Re: **LETTER OF TRANSMITTAL  
ROOMS TO GO STORE EXPANSION AND REMODEL  
18722 South Dixie Highway  
Cutler Bay, FL 33157  
POST BID ADDENDUM #5**

## **POST BID ADDENDUM NO. FIVE**

Incorporate the following revised CASCO drawings dated 01/29/2024, with revisions including, but not necessarily limited to, those listed below:

**WALL SECTIONS**

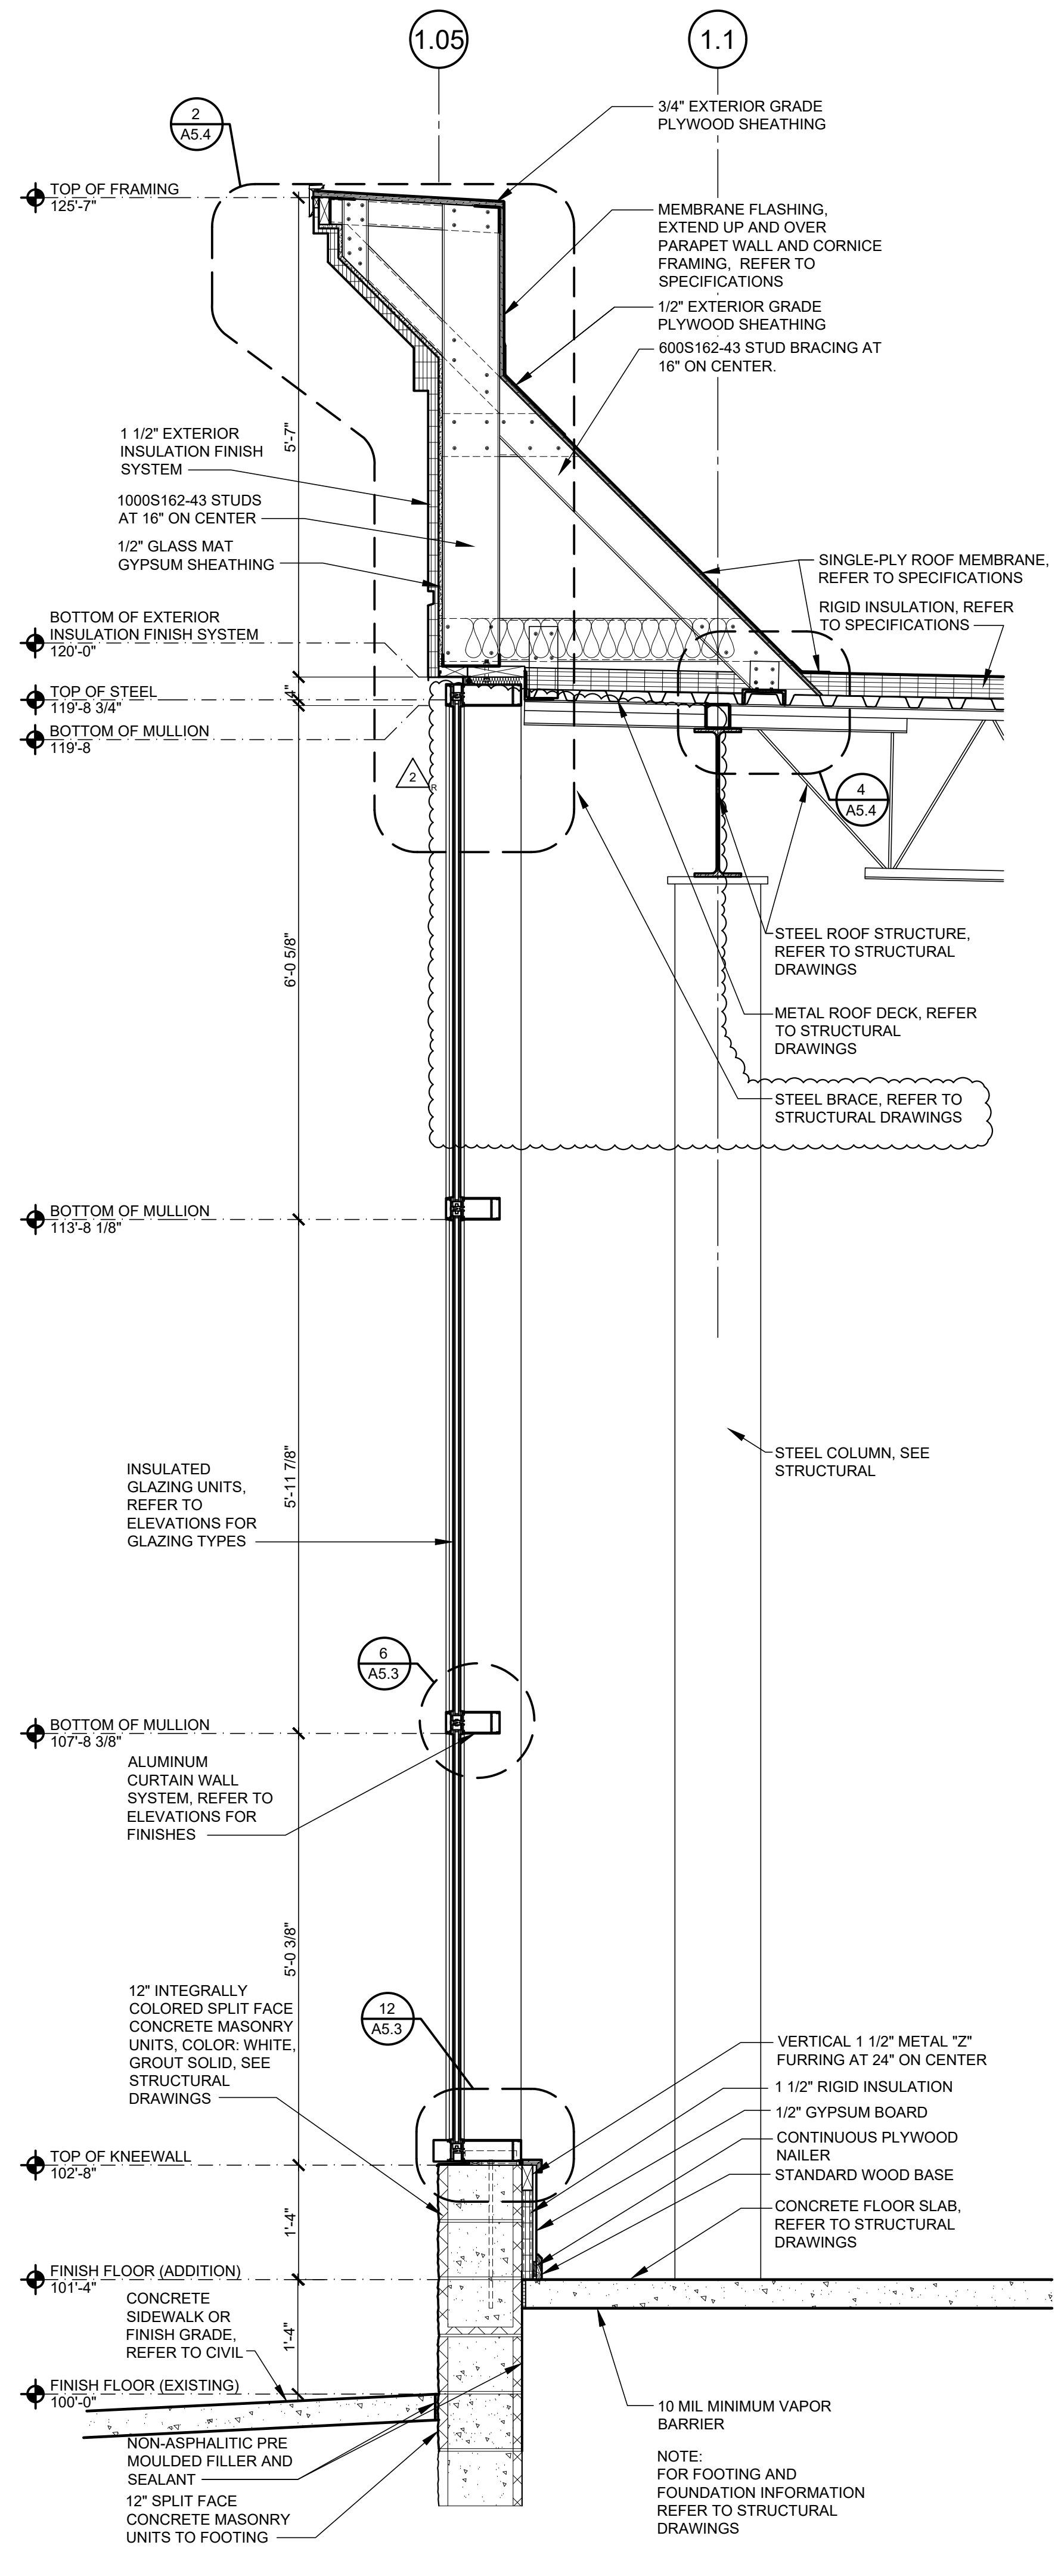
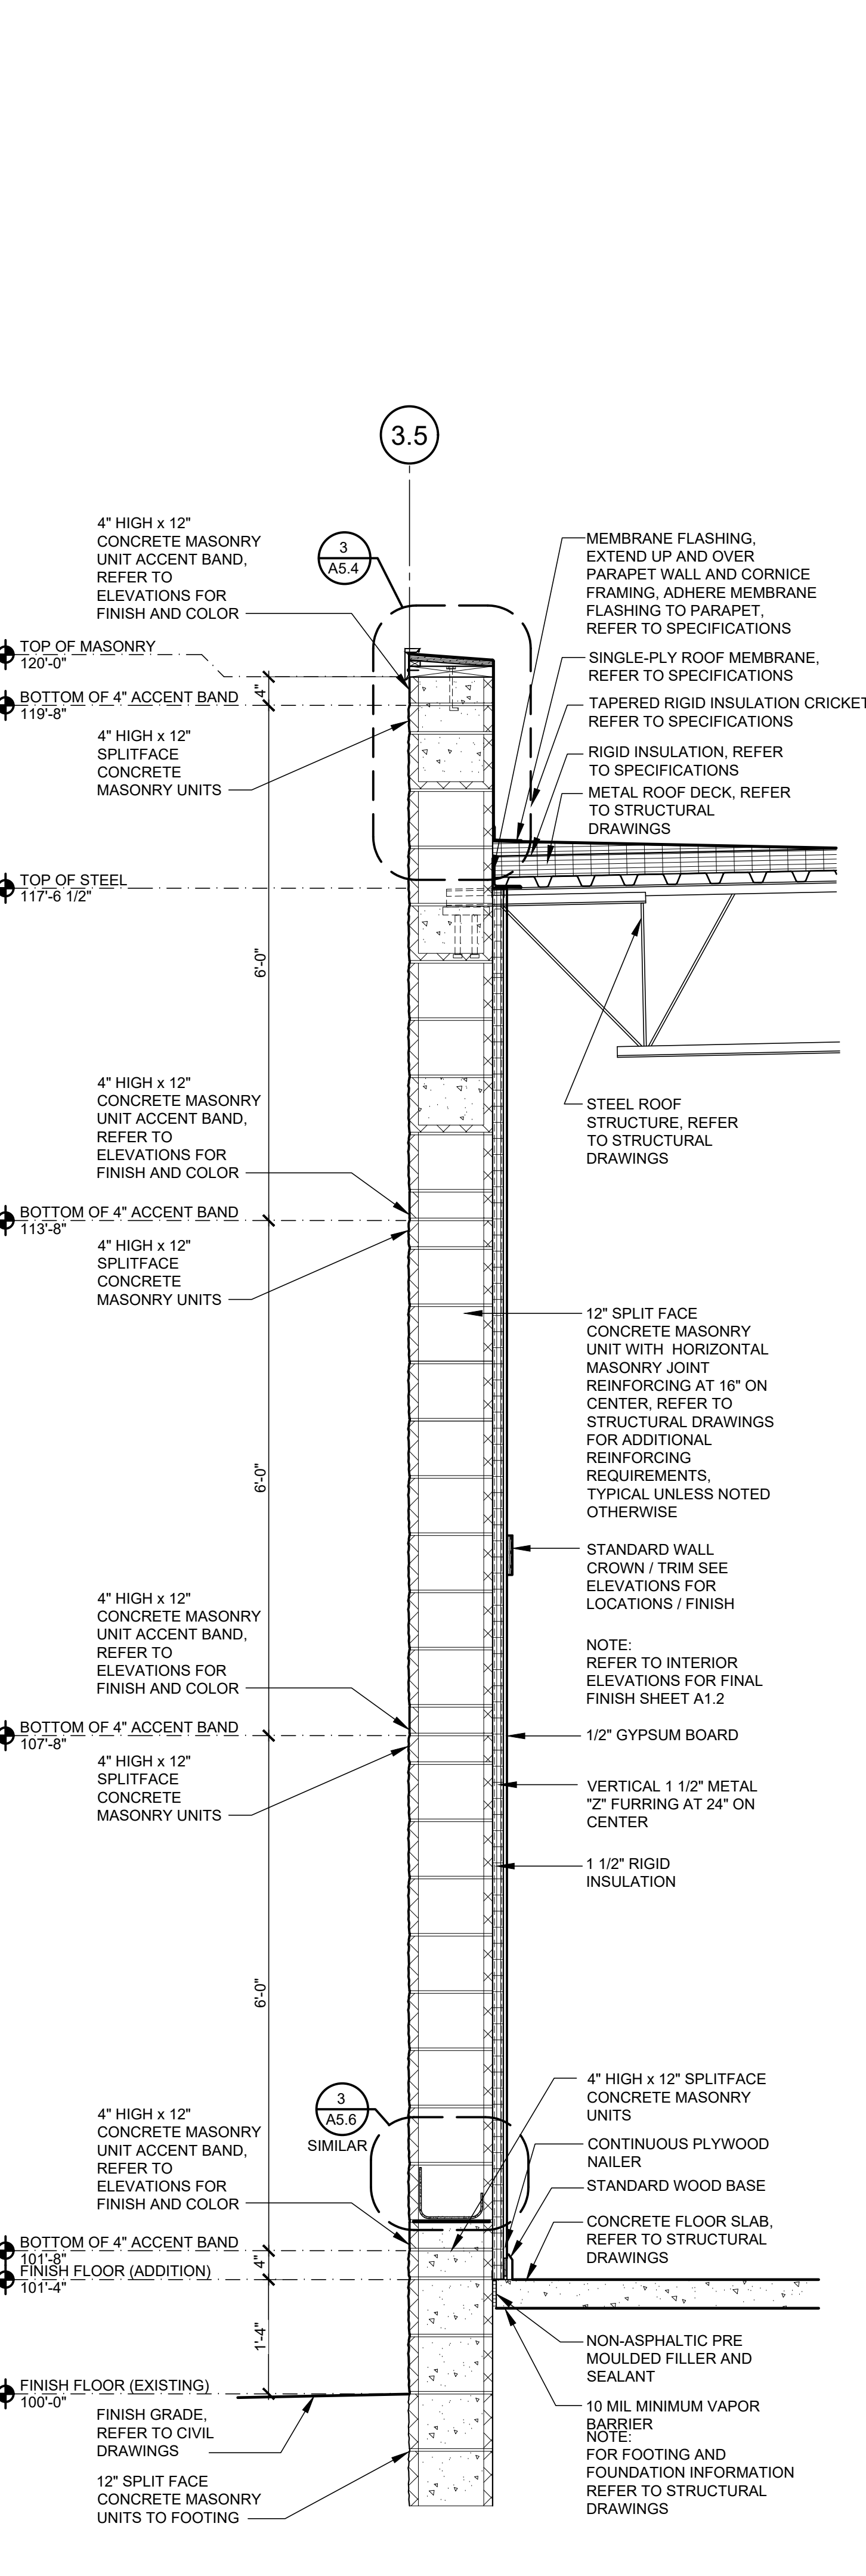
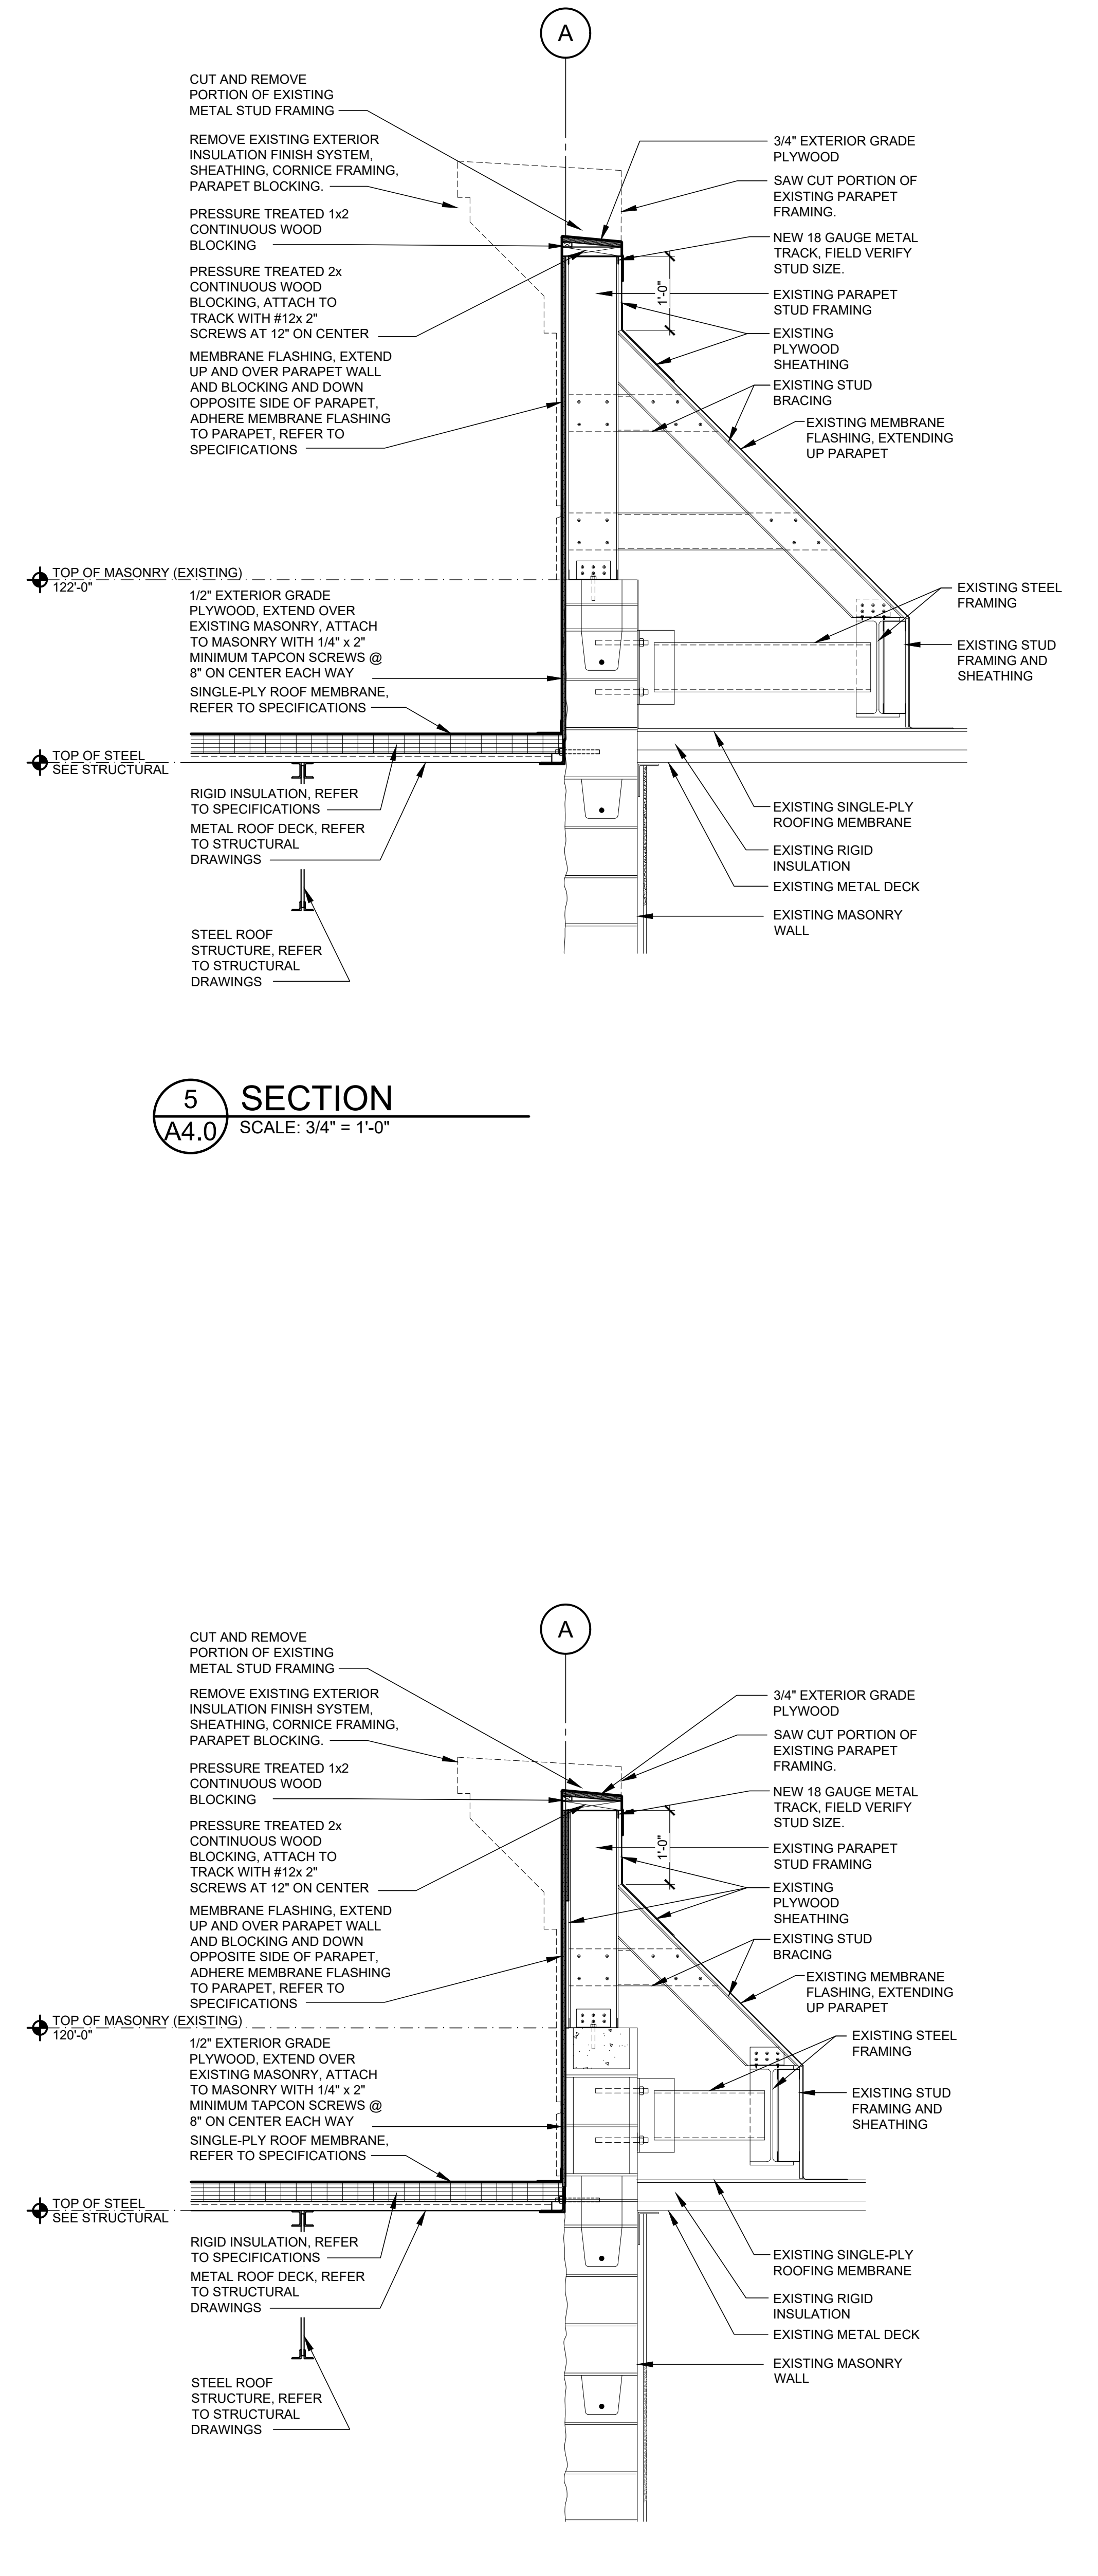
12. Sheet A4.0 – Revision No. 1: Removed Storefront steel bracing.
13. Sheet A5.0 – Revision No. 1: Added notes re: apply fire caulk... to Partition Type P-12. Revise 362S162-33 metal studs to 362S163-18 metal studs.
